POST/HAZELTINE ASSOCIATES
Architectural Historians

1.0 INTRODUCTION AND REGULATORY FRAMEWORK

1) A revised lighting plan addressing HLC comments made on January, 27, 2016 has been prepared.

Location of Exterior Lanterns (Sheet LT2.30)

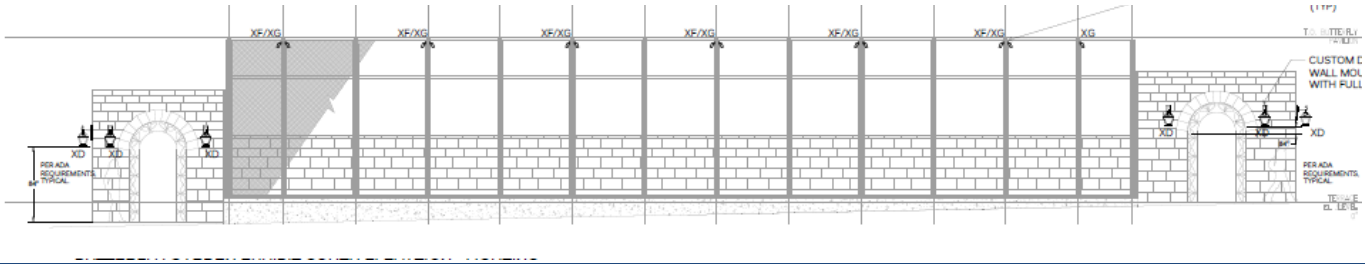
The proposed design of the lanterns meets the Secretary of the Interior's Standards for Rehabilitation for the following reasons: 1) The vestibules' exterior lanterns have been redesigned to create a design that has a more distinctive sense of place and is more referential to the Museum's historic hand-crafted Spanish Colonial Revival style light fixtures(see below); 2) The fixtures will be hand-crafted wrought metal to emulate the quality and appearance of the institution's remaining Spanish Colonial Revival style lighting; 3) the fixtures, composed of a lantern, hook designed to reference a tree branch capped by a buttefly and a 5-inch by 8-inch rectangular backplate, feature a traditional design that references, but does not copy, the lantern type fixtures flanking the main entrance to the Museum; 4) The lanterns' glazing is traditional in type, finish and appearance; 5) The incorporation of natural motifs, in this case, a butterfly on the hook and a branch and tree motif on the lantern top, is within the tradition of Spanish Colonial Revival light fixtures including the period lantern located in Fleischmann Auditorium's loggia which features foliate details; and 6) As demonstrated in Figure LT1.10N, the proposed fixtures would not produce excessive

glare or lighting that would disrupt the nighttime appearance of the Museum's setting or the cultural landscape. Therefore, because the proposed lighting is referential to its historic setting, will not impair the historic setting or the surrounding cultural landscape and could be removed in the future with no impacts to significant historic resources, the design and placement of the lanterns meets Standards 9 & 10.

Location of Interior Vestibule Lighting (Sheet LT2.40)

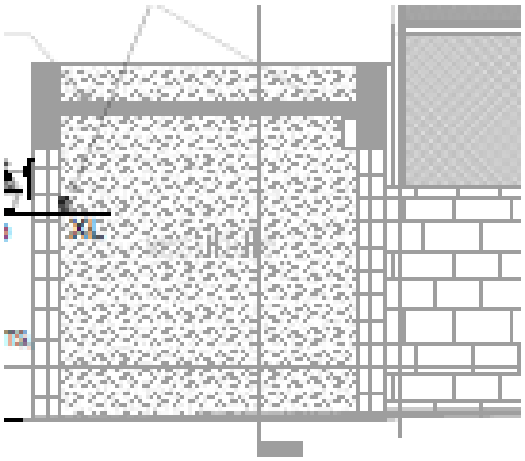
The proposed lighting for the interior of the vestibules meets the Secretary of the Interior's Standards for Rehabilitation for the following reasons: 1) The fixtures are reductive in design since these areas serve as a transition to the exhibit space and are not visible from the exterior (see Sheet LT3.1); 2) The fixture type is modest in scale and will be painted to match the appearance of the painted ribs supporting the netting (fixture type XL); 3) Because the fixtures are not visible from the exterior their reductive design would not impair the historic setting or surrounding cultural landscape; 4) As demonstrated in Figure LT1.10N, the proposed fixtures

would not produce excessive glare or lighting that would disrupt the nighttime appearance of the Museum's setting or the cultural landscape and 5)Moreover, the fixtures could be removed in the future with no significant impacts to significant historic resources. Therefore, the proposed design of the vestibules' interior lighting meets Standards 9 & 10.

Elevation of Butterfly Garden Exhibit (Sheet LT2.30)

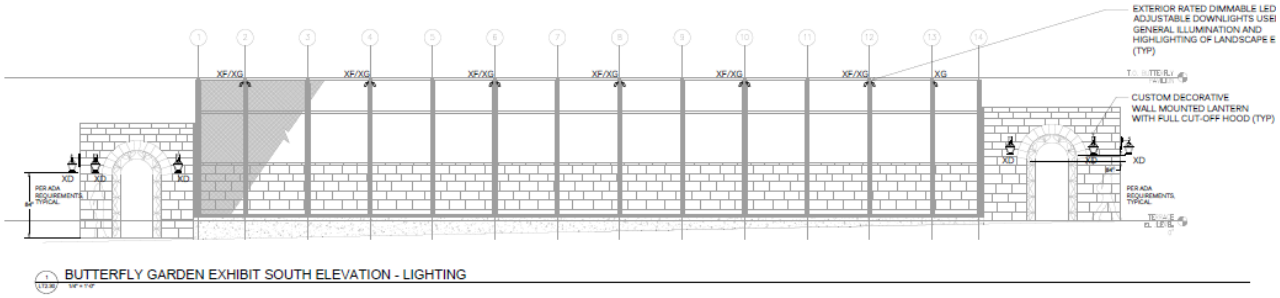
The proposed design of the Butterfly Exhibit Garden's interior lighting meets the Secretary of the Interior's Standards for Rehabilitation for the following reasons: 1) The dimensions of the

lighting fixtures have been reduced to the minimum required to address the lighting needs of the exhibit space; 2) The design of the fixtures is reductive and does not include references to historic light fixture types because the exhibit space is not a traditional building type and the intent is to have the fixtures meld into the landscaping and the armature that supports the exhibit's netting rather than read as distinctive visual elements; 3) The fixtures will either be enmeshed in the landscaping, attached to the exhibit's metal supports (which they will match in color and material) or within the ornamental water feature, which will help ensure the fixtures recede into the background; and 4) As demonstrated in Figure LT1.10N, the proposed fixtures would not produce excessive glare or lighting that would disrupt the nighttime appearance of the Museum's setting or the cultural landscape Therefore, implementation of the proposed lighting for the interior of the Butterfly Garden Exhibit would not impair significant historic resources or the surrounding cultural landscape, this element of the lighting plan meets Standard 9. Standard 10 is met because the lighting could be removed in the future with no substantial impacts to significant historic resources.

Location of exterior lighting (Sheet LT1.10)

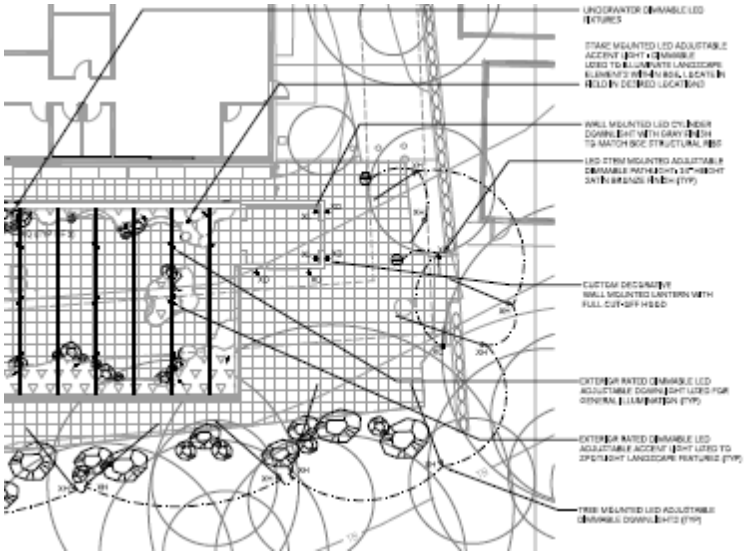
Exterior lighting is confined to tree lights attached to the limbs of existing mature trees and a number of stem-mounted metal light fixtures as detailed above. The installation of the ground and tree-mounted fixtures meets the Secretary of the Interior's Standards for Rehabilitation for the following reasons: 1) The ground-mounted lights are modest in scale (2 feet tall) and have been designed to blend into the enhanced landscaping planned for the base of the sandstone-clad wall; 2) The light fixtures will recede into the landscape and will be limited to a small number; 3) The tree-mounted fixtures, which would be attached to the trees by adjustable tree straps or, where possible, tree rings, have been designed to blend into the foliage; 4) The tree-mounted lights will not be permanently attached to the trees and could be removed in the future; 5) As demonstrated in Figure LT1.10N, the proposed fixtures would not produce excessive glare or lighting that would disrupt the nighttime appearance of the Museum's setting or the cultural landscape. Therefore, the ground-mounted and tree mounted fixtures would not substantially affect the setting of nearby historic resources or the surrounding cultural landscape and the proposal for installing exterior lighting at the Butterfly Garden Exhibit, which would not substantially affect the setting of nearby historic resources or the surrounding cultural landscape and therefore, meets Standard 9. Standard 10 is met because the fixtures could be removed in the future with no impacts to significant historic resources or the surrounding cultural landscape.

Site Plan with proposed lighting locations (Sheet LT1.10)

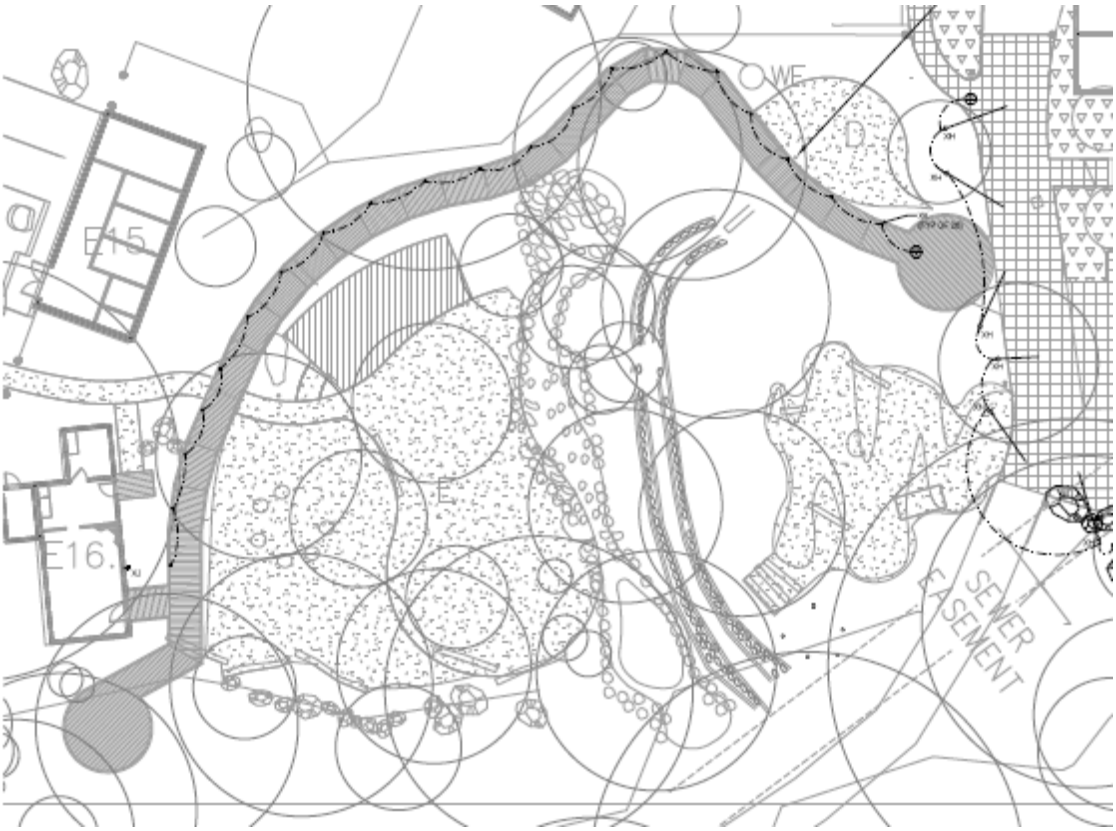
The final plan includes pathway lighting integrated into the proposed boardwalk's Trex decking. The wattage and number of proposed lighting fixtures for the boardwalk have been reduced to the minimum necessary to safely guide people between MacVeagh Cottage and Butterfly Garden Exhibit. The lights are small in scale and would be set nearly flush into the boardwalk decking which would reduce their visibility. The locations of the light fixtures are detailed on Sheet LT1.10.

The installation of the deck-mounted fixtures meets the Secretary of the Interior's Standards for

Rehabilitation for the following reasons: 1) The deck-mounted lights are small in scale and set nearly flush to reduce their visibility; 2) The use of deck-mounted fixtures would eliminate the need for pole mounted fixtures, which will help maintain the semi-rural quality of the landscape; and 3) As demonstrated in Figure LT1.10N, the proposed fixtures would not produce excessive glare or lighting that would disrupt the nighttime appearance of the Museum's setting or the cultural landscape. Therefore, the proposal to mount pathway lighting into the boardwalk's decking would not substantially affect the setting of nearby historic resources or the surrounding cultural landscape and therefore, meets Standard 9. Standard 10 is met because the fixtures could be removed in the future with no impacts to significant historic resources or the surrounding cultural landscape.

Location of Existing and Proposed Replacement Fixture (Sheet LT3.3)

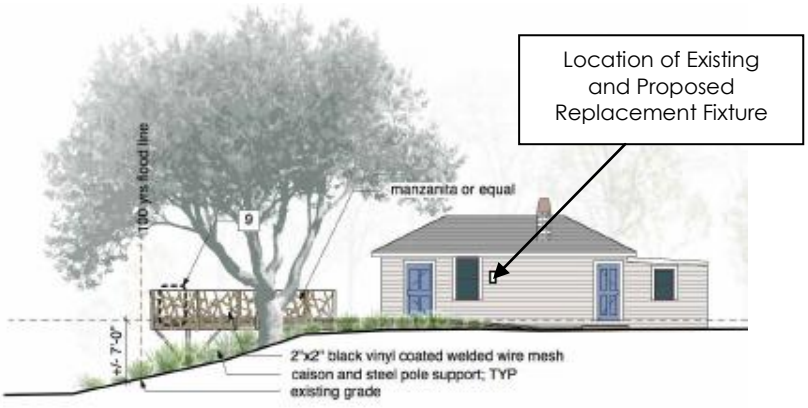
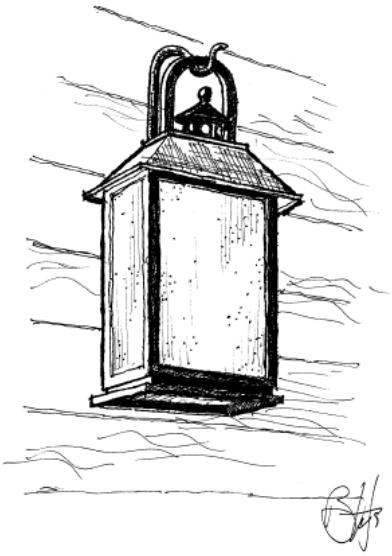
The design of the replacement light fixture flanking the north side of the window located on the north of the main entrance to the cottage has been revised. The new fixture would be a handcrafted pendant style wrought iron fixture fabricated by Steve Handleman, which draws its design inspiration from early 20th century lighting fixtures (Sheet LT3.3). The four-sided lantern style fixture would be 6.5 inches wide, 16.5 inches tall and a diameter of 8.5 inches. Glazing would be single sheets of diffused glass and the lantern's cap would be solid to direct light towards the ground. The lantern would be suspended from wrought metal hook attached to a rectangular metal plate that would be affixed to the cottage's wall.

The proposed design for the lighting fixture near the entrance to MacVeagh Cottage meets the Secretary of the Interior's Standards for Rehabilitation for the following reasons: 1) The lighting fixture is modest in scale and is not out of proportion with the cottage's east elevation; 2) The design of the fixture while recalling Arts and Crafts style light fixtures in its materials and handcrafting maintains a clear distinction between old and new; 3) As demonstrated in Figure LT1.10N, the proposed fixture would not produce excessive glare or lighting that would disrupt the nighttime appearance of the Museum's setting or the cultural landscape Therefore, implementation of the proposed lighting for MacVeagh Cottage meets Standard 9. Standard 10 is met because the lighting could be removed in the future with no substantial impacts to significant historic resources.

Location of refurbished Fixture (Sheet LT1.11)

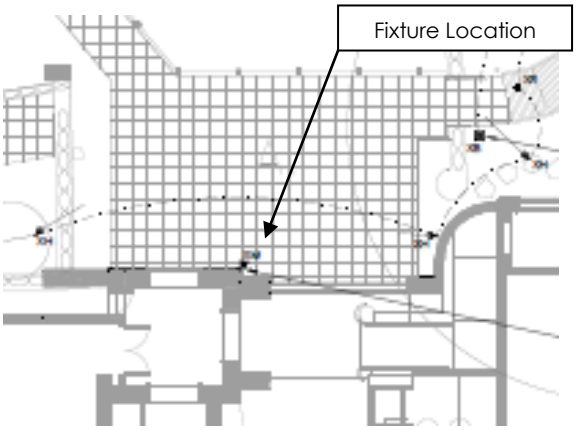
The refurbishment of the existing lantern meets the Secretary of the Interior's Standards for Rehabilitation for the following reasons: 1) The existing lantern is not a historic lighting fixture and its alteration will not impair a historic feature of the building; 2) Refurbishing the lantern to lend it a more handcrafted look would enhance its consistency with the building's Spanish Colonial Revival style architecture and the existing historic lighting; 3) As demonstrated in Figure LT1.11N, the proposed fixture would not produce excessive glare or lighting that would disrupt the nighttime appearance of the Museum's setting or the cultural landscape. Therefore, the proposal to refurbish the existing fixture would not substantially affect the architectural integrity of the Fleischmann Loggia or the surrounding cultural landscape and therefore, meets Standard 9. Standard 10 is met because the fixture could be removed in the future with no impacts to significant historic resources or the surrounding cultural landscape.

Location of replicated Fixture (Sheet LT1.11)

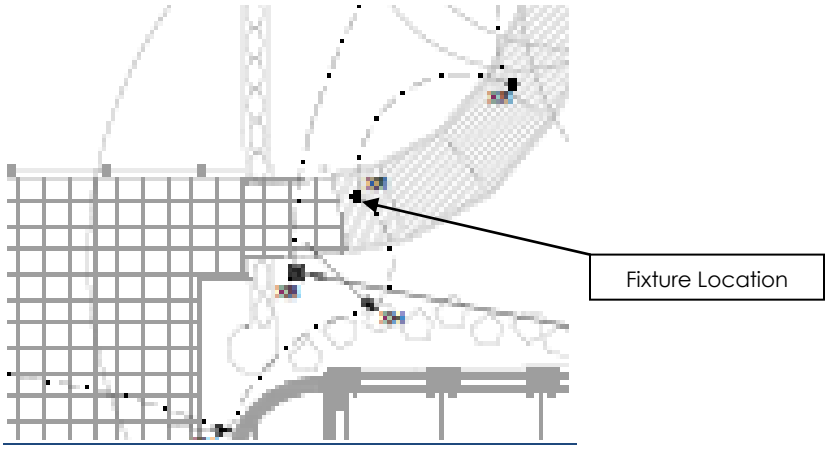
Installing a copy of the existing lantern meets the Secretary of the Interior's Standards for Rehabilitation for the following reasons: 1)the replication of a single historic light fixture would not impair the historic appearance of the Museum's street façade or the Hazard estate wall; 2) the lantern would be handcrafted to match the design, material and finish of the historic fixture, which maintain the character of the nearby historic lighting; 3) As demonstrated in Figure LT1.11N, the proposed fixture would not produce excessive glare or lighting that would disrupt the nighttime appearance of the Museum's setting or the cultural landscape. Therefore, the proposal to install a copy of the owl lantern at the approved new entrance through Hazard Estate wall not substantially affect the architectural integrity of the significant historic resources or the surrounding cultural landscape and therefore, meets Standard 9. Standard 10 is met because the fixture could be removed in the future with no impacts to significant historic resources or the surrounding cultural landscape.

Location of Tree Lighting (Sheet LT1.11)

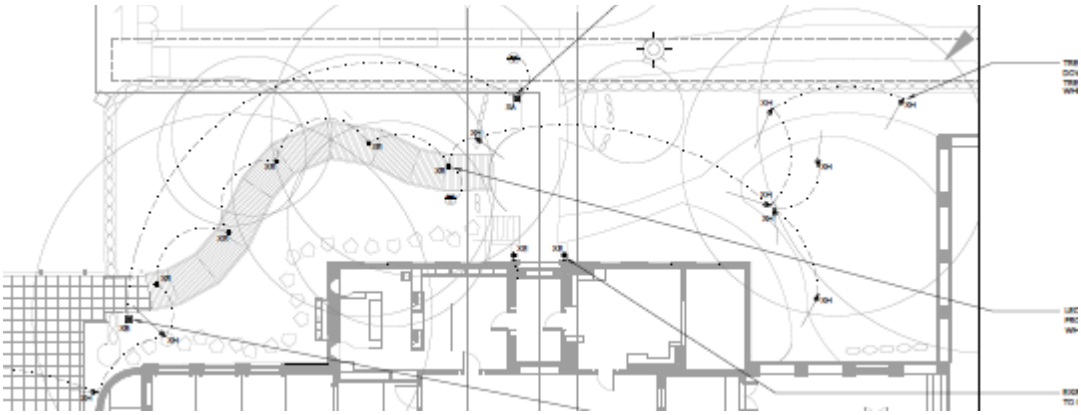
The tree-mounted lighting meets the Secretary of the Interior's Standards for Rehabilitation for the following reasons: 1) The tree-mounted fixtures and their supports would be attached to the trees with an adjustable strap or, where possible, "tree rings" (see fixture type XR, XH & Sheet LT1.11); 2) The tree-mounted lighting will not be permanently attached to the trees and could be removed in the future; 3) As demonstrated in Figure LT1.11N, the proposed fixtures would not produce excessive glare or lighting that would disrupt the nighttime appearance of the Museum's setting, including Puesta del Sol, the façade of the Museum or the surrounding cultural landscape or its semi-rural setting. Therefore, the proposal to install tree-mounted fixtures in the vicinity of the plaza meets Standard 9. Standard 10 is met because the fixtures could be removed in the future with no impacts to significant historic resources or the surrounding cultural landscape.

Location of Refurbished Lanterns

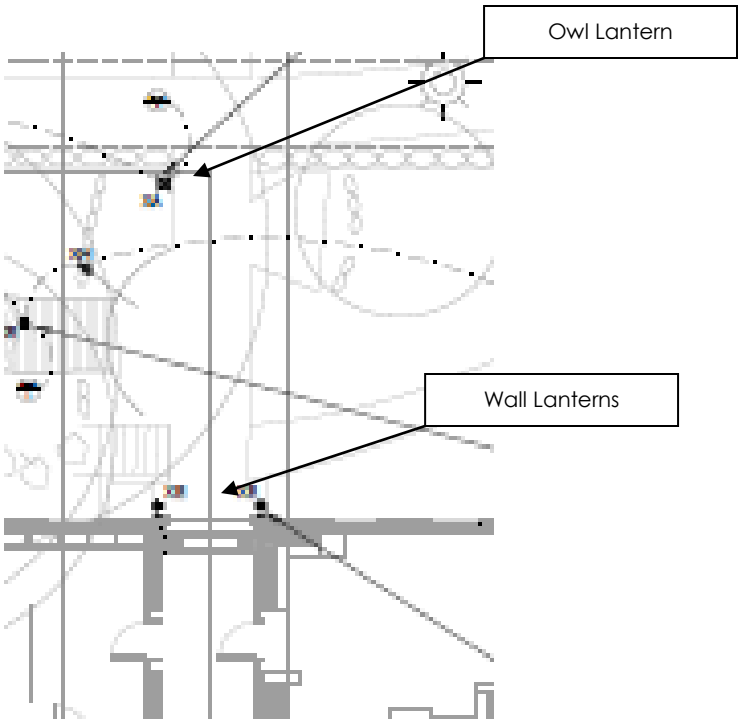
Analysis: The restoration of the historic lighting fixtures meets the Secretary of the Interior's Standards for Rehabilitation for the following reasons: 1) The restoration would cleaning and repair the metalwork and glass, which would help preserve these features; 2) The light fixtures patina would be preserve to maximum extent feasible: 3) If florescent bulb types are installed they diffusing shades will be installed to meet the guidance outlined in the City of Santa Barbara Outdoor Streetlight and Design Guidelines in the summary of changes dated February 10, 2009. With the implementation of this guidance, the restoration of the lanterns would meet Standard 6.

Location of Tree-mounted lighting (Sheet LT1.11)

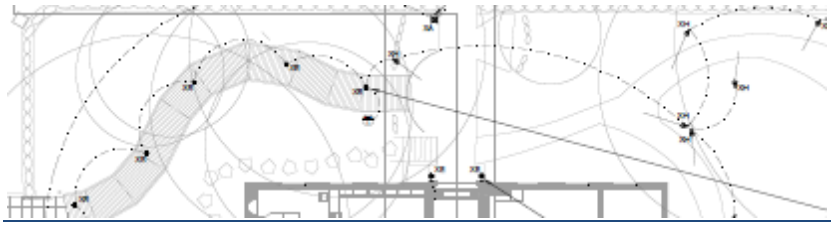
The tree-mounted lighting meets the Secretary of the Interior's Standards for Rehabilitation for the following reasons: 1) The tree-mounted fixtures and their supports would be attached to the trees with an adjustable strap or, where possible, "tree rings" have been designed to blend into the foliage (see fixture type XR & XH, Sheet LT1.11); 2) The tree-mounted lighting will not be permanently attached to the trees and could be removed in the future; 3) As demonstrated in Figure LT1.11N, the proposed fixtures would not produce excessive glare or lighting that would disrupt the nighttime appearance of the Museum's setting, including Puesta del Sol, the façade of the Museum or the surrounding cultural landscape or its semi-rural setting. Therefore, the proposal to install tree-mounted fixtures along the north elevation of the Museum on Puesta del Sol meets Standard 9. Standard 10 is met because the fixtures could be removed in the future with no impacts to significant historic resources or the surrounding cultural landscape.

Location of Lighting (Sheet LT1.12)

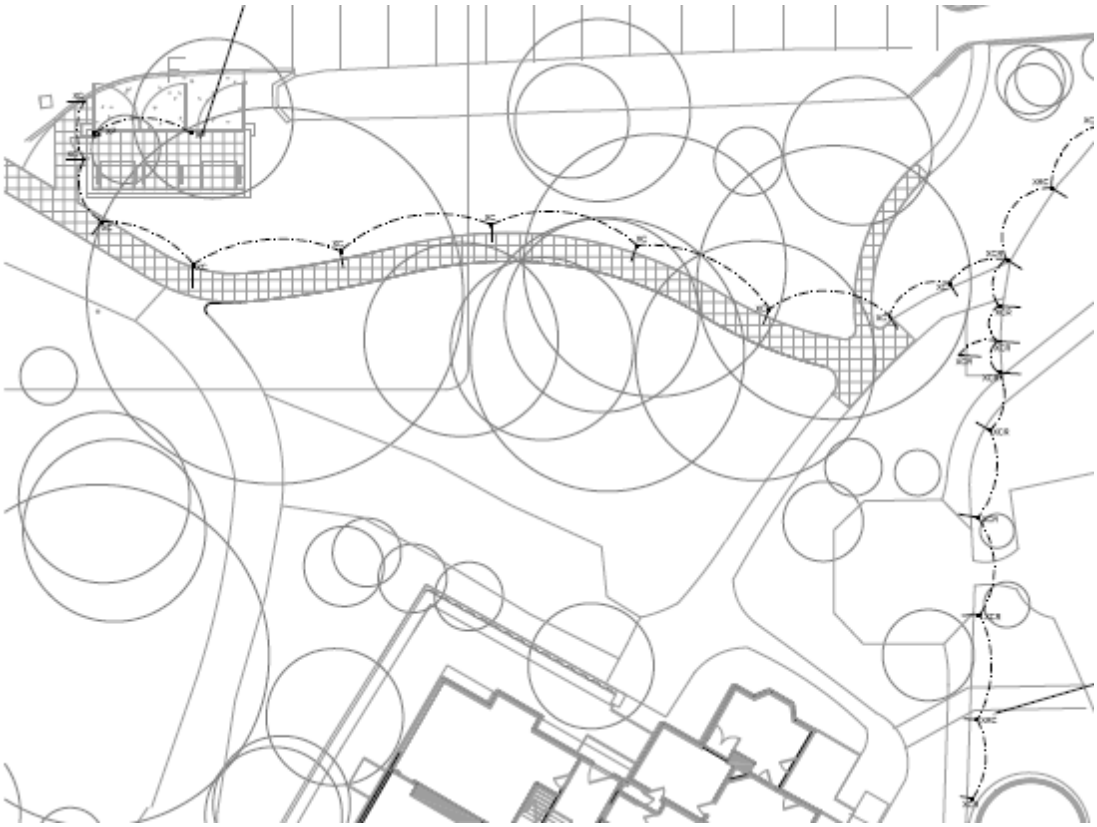
The installation of the ground-mounted fixtures meets the Secretary of the Interior's Standards for Rehabilitation for the following reasons: 1) The ground-mounted lights are modest in scale (2 feet tall) and have been designed to blend into the enhanced landscaping planned for the base of the sandstone-clad wall; 2) The light fixtures will recede into the landscape and will be limited to a small number; and 3) As demonstrated in Figure LT1.12N, the proposed fixtures would not produce excessive glare or lighting that would disrupt the nighttime appearance of the Museum's setting or the cultural landscape. Therefore, the ground-mounted light fixtures would not substantially affect the setting of nearby historic resources or the surrounding cultural landscape and meets Standard 9. Standard 10 is met because the fixtures could be removed in the future with no impacts to significant historic resources or the surrounding cultural landscape.

Fixture Type XP
Interior lighting for Trash Enclosure

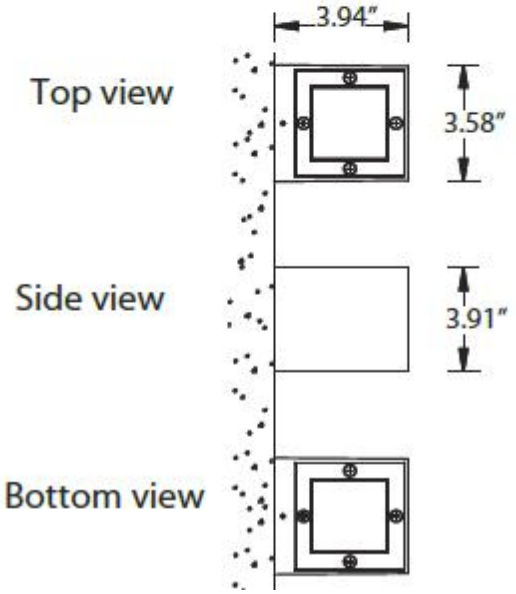
The installation of two wall-mounted light fixtures within the interior of the Trash Enclosure meets the Secretary of the Interior's Standards for Rehabilitation for the following reasons: 1) The fixtures are modest in scale and will be painted to match the color and matte finish of the Museum's existing fixtures; 2) The light fixtures are not located on a historic building, structure, feature or landscape element; 3) the fixtures are mounted to the interior walls of the Trash Enclosure and would not be visible from the surrounding landscape; and 4) As demonstrated in Figure LT1.12N., the proposed fixtures would not produce excessive glare or lighting that would disrupt the nighttime appearance of the Museum's setting or the cultural landscape. Therefore, the trash enclosure's light fixtures would not substantially affect the setting of nearby historic resources or the surrounding cultural landscape and meets Standard 9. Standard 10 is met because the fixtures could be removed in the future with no impacts to significant historic resources or the surrounding cultural landscape.
